Sun SPARC® Enterprise M8000/M9000 Servers Product Notes

For XCP Version 1060

Part No. 820-3611-10
November 2007, Revision A

FIGURE 1 Sun SPARC Enterprise M8000 Server + Power Cabinet Bottom View

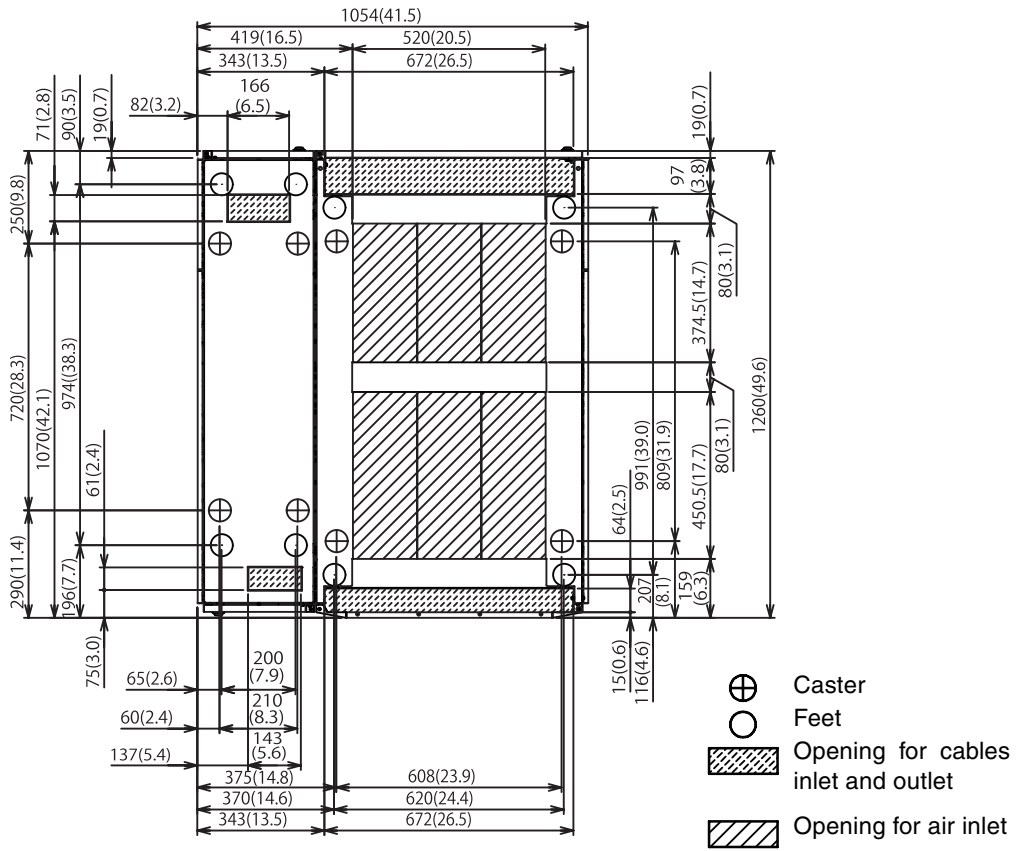
The following figures are a correction to the description in Section 1.2.2.2, "Bottom View of the Components".

FIGURE 1 shows the Sun SPARC Enterprise M8000 Server + Power Cabinet Bottom View.
